1 LAWSON SQUARE
REDFERN

for
LAWSON SQUARE PTY LTD.

SECTION 96 APPLICATION
ISSUE J
07 DECEMBER 2017

SCHEDULE OF
KEY AMENDMENTS

DRAWING:
ELEVATIONS SHEET 3
TOWER 2 - EAST & WEST ELEVATIONS

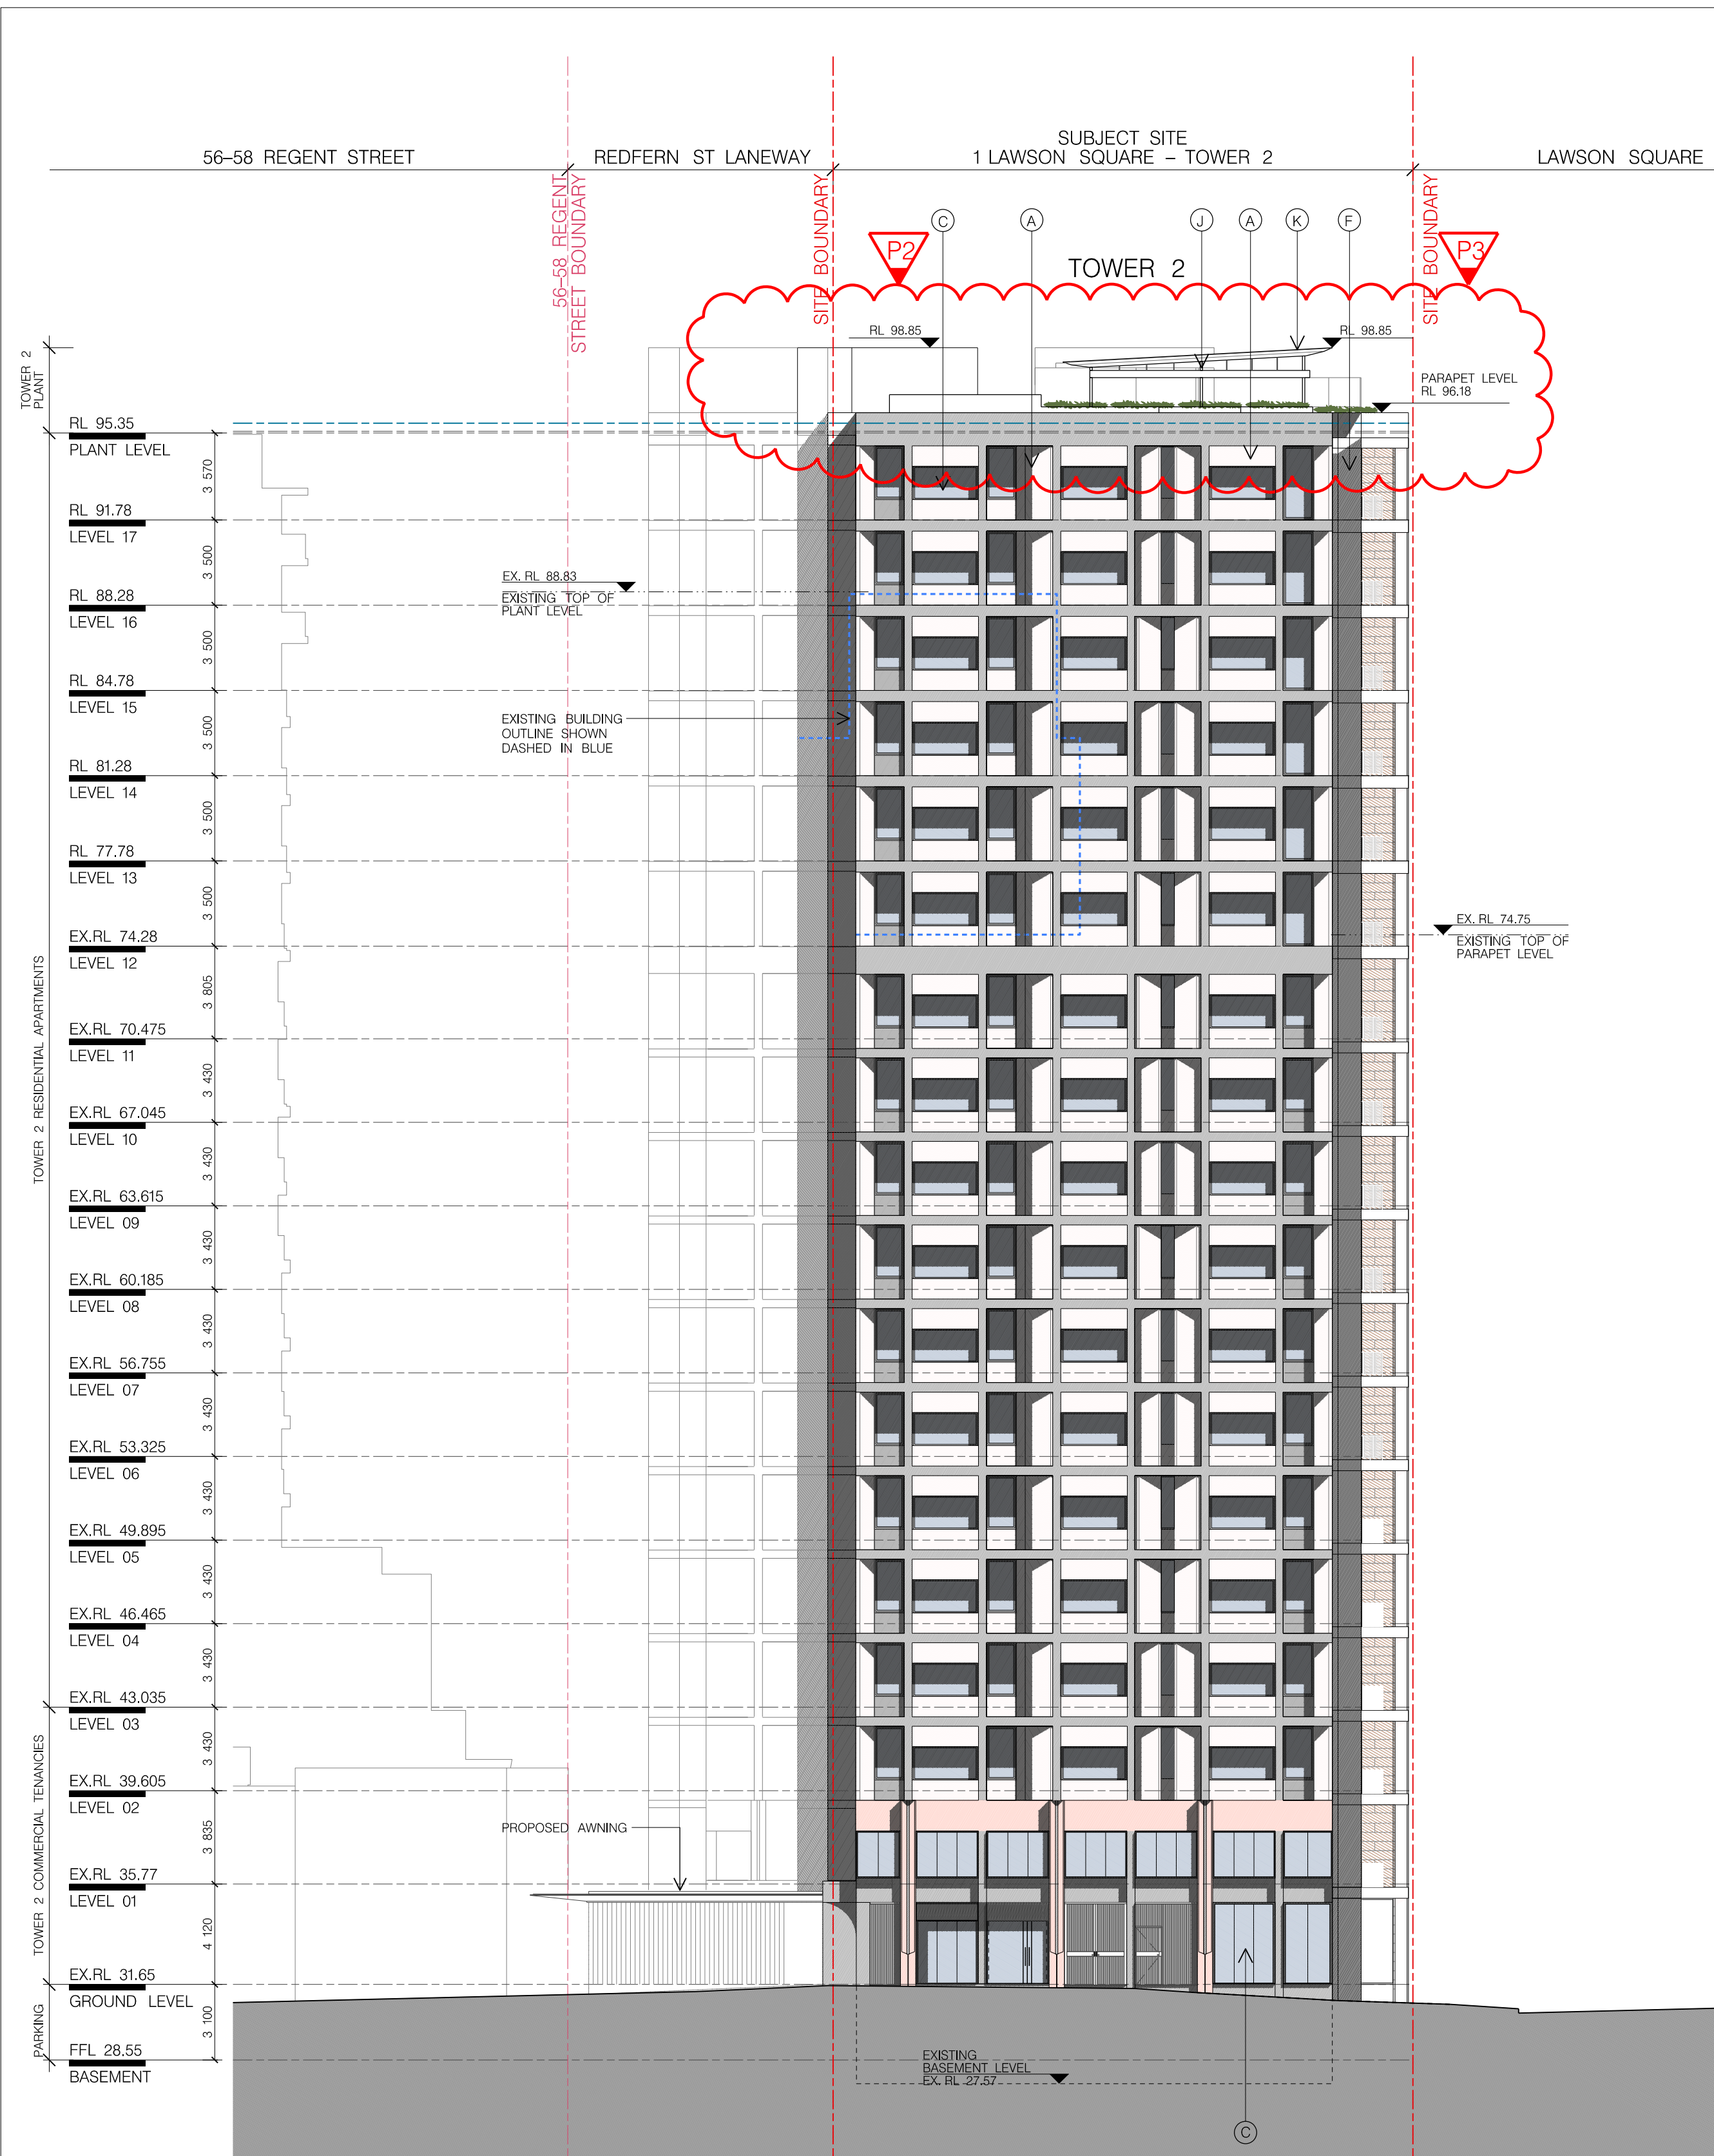
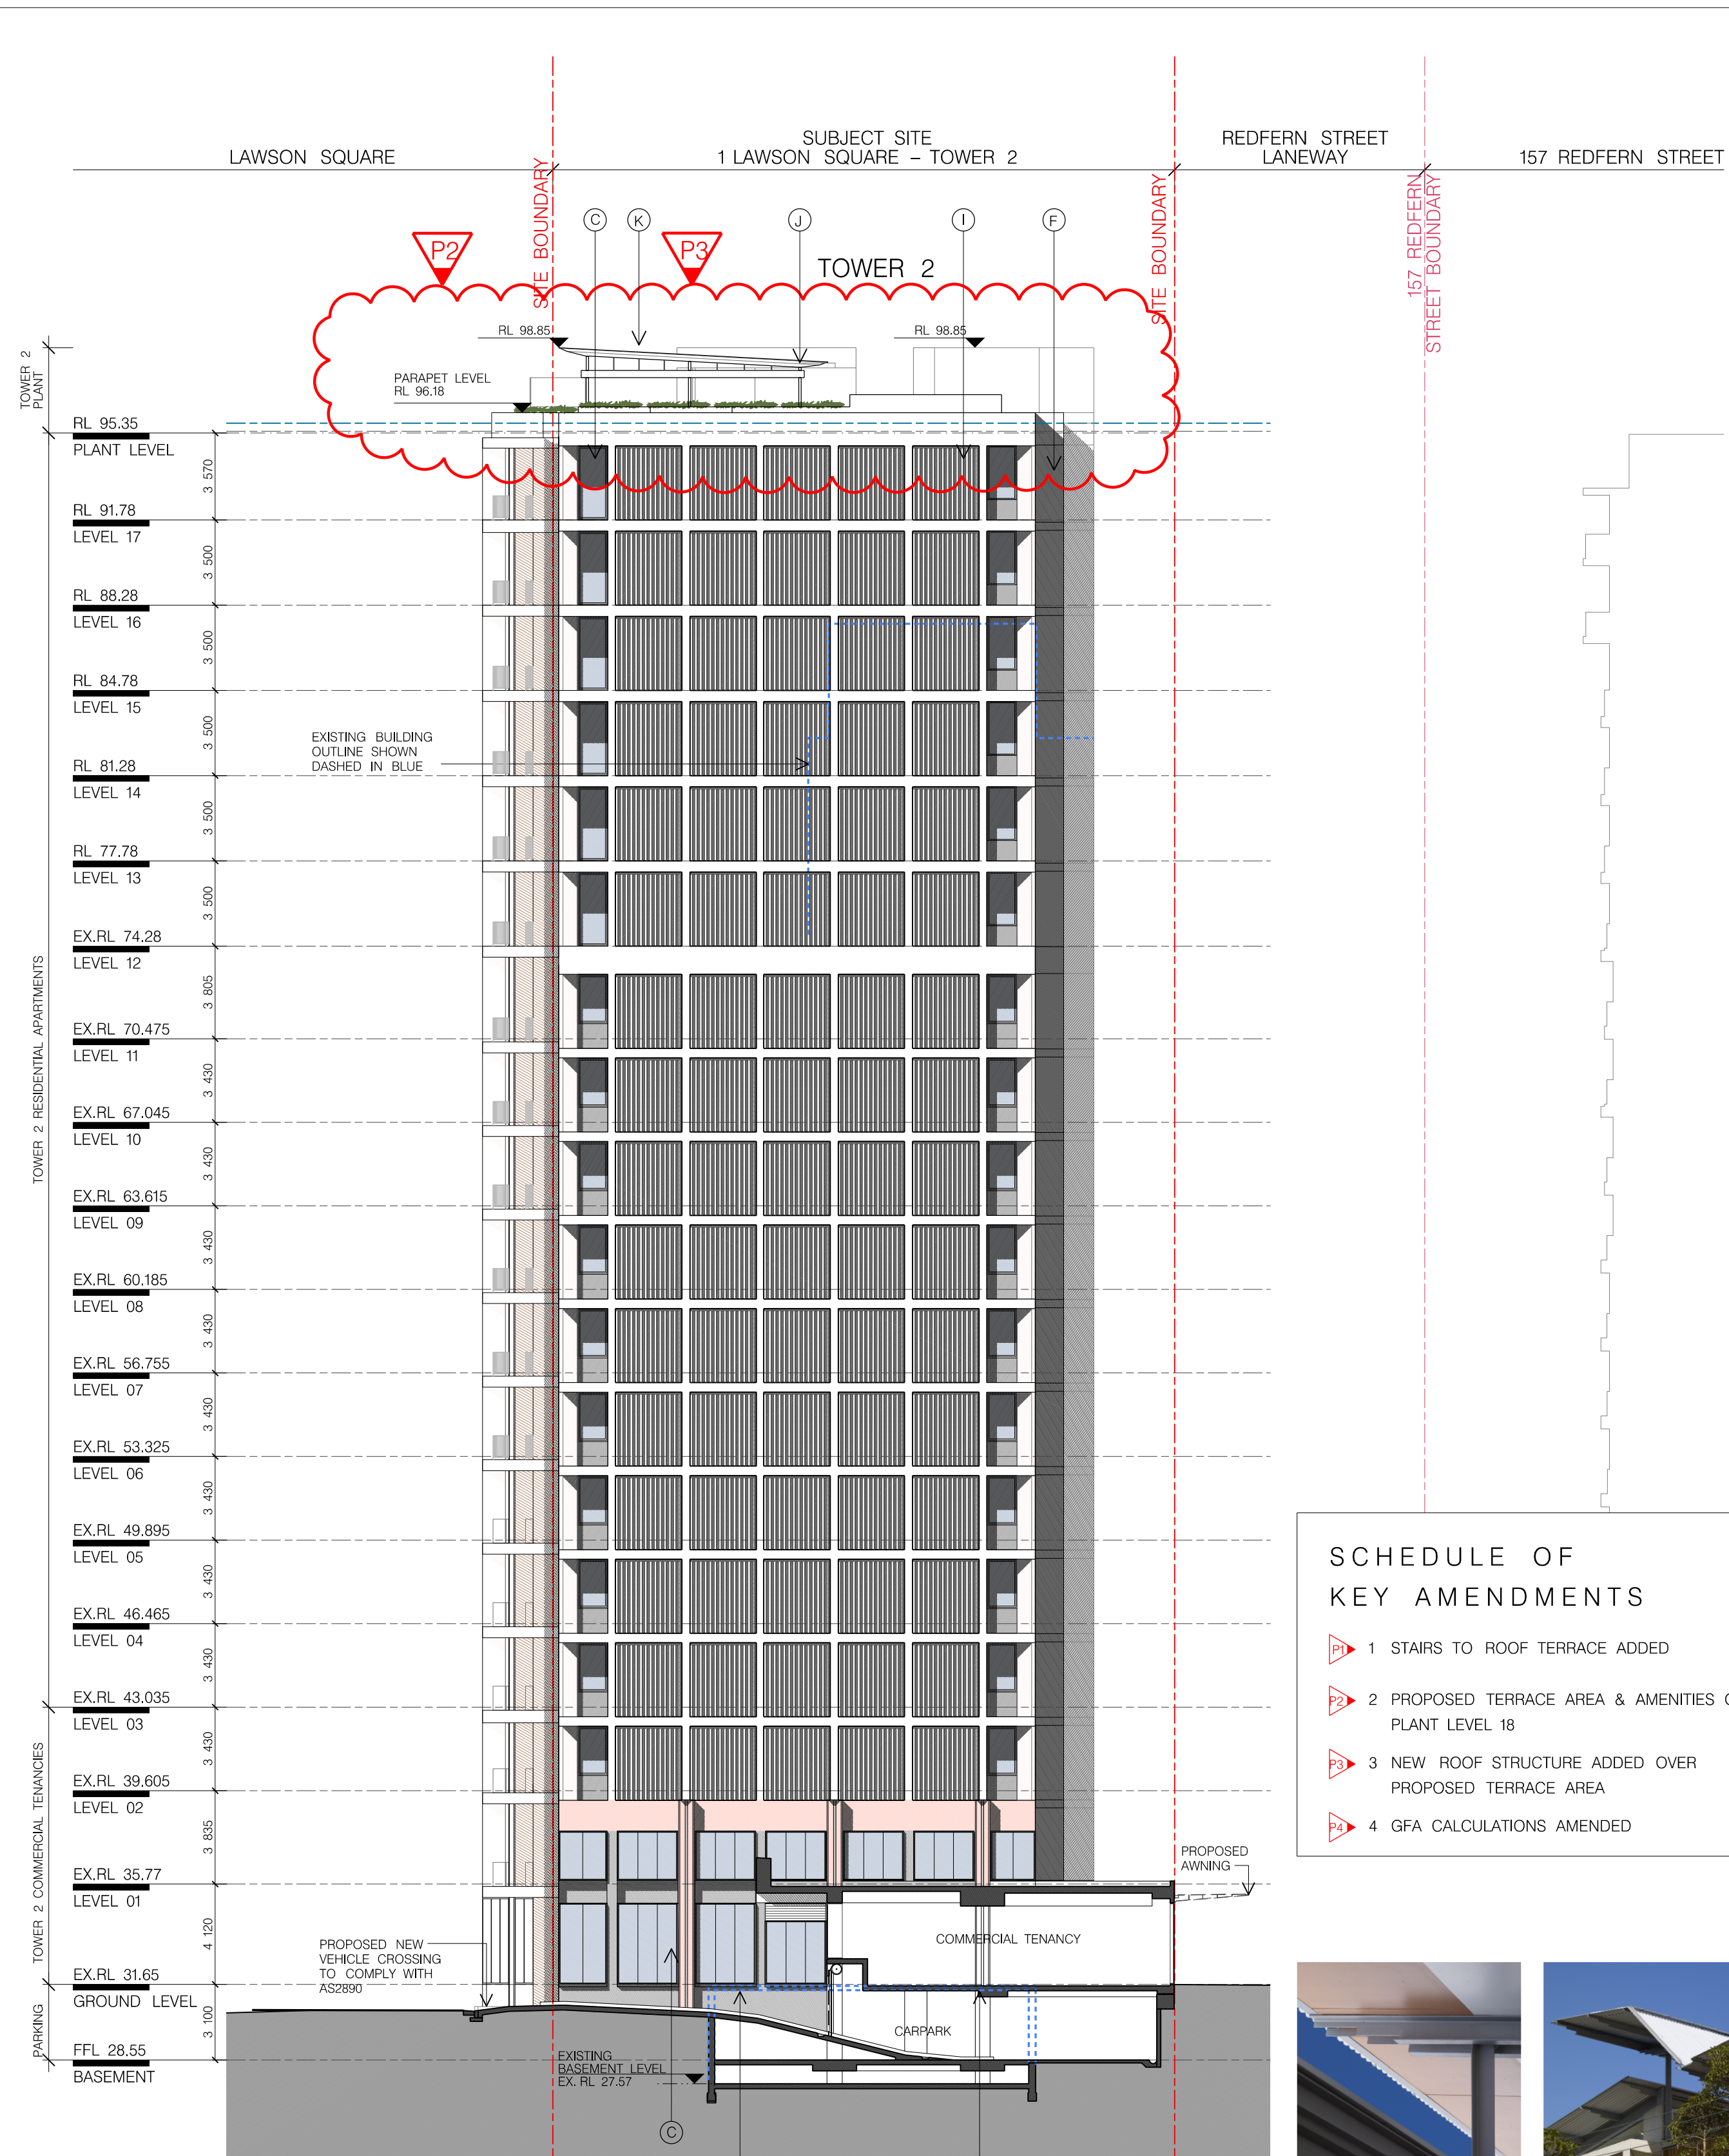
SCHEDULE OF KEY AMENDMENTS	
	1 STAIRS TO ROOF TERRACE ADDED
	2 PROPOSED TERRACE AREA & AMENITIES ON PLANT LEVEL 18
	3 NEW ROOF STRUCTURE ADDED OVER PROPOSED TERRACE AREA
	4 GFA CALCULATIONS AMENDED

DRAWING:
AREA CALCULATIONS

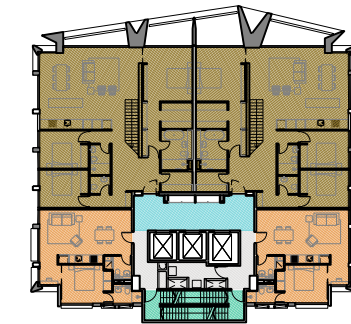
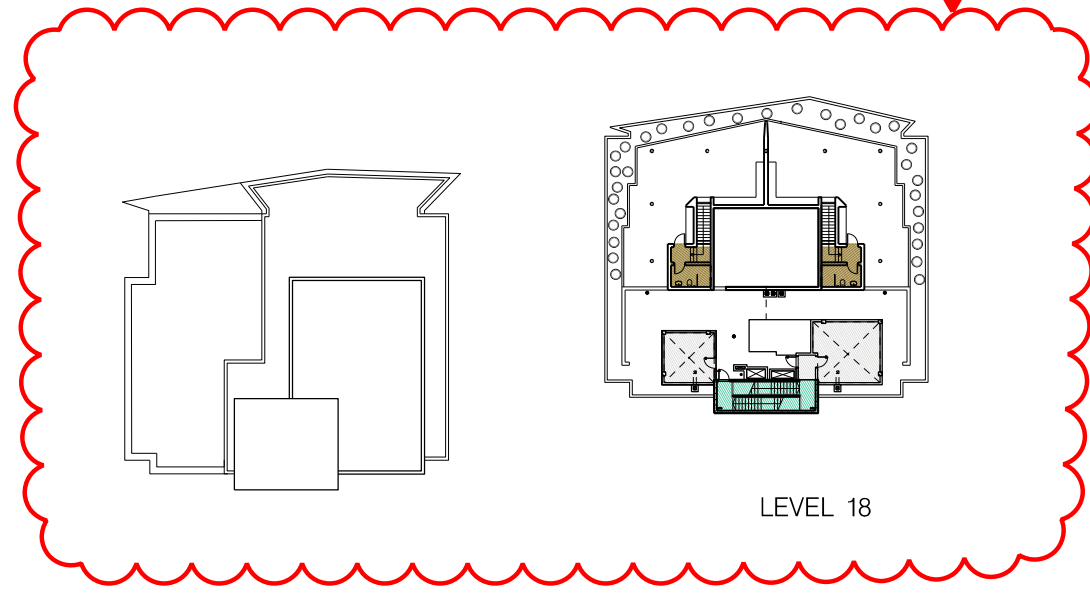
- 1 STAIRS TO ROOF TERRACE ADDED
- 2 PROPOSED TERRACE AREA & AMENITIES ON PLANT LEVEL 18
- 3 NEW ROOF STRUCTURE ADDED OVER PROPOSED TERRACE AREA
- 4 GFA CALCULATIONS AMENDED
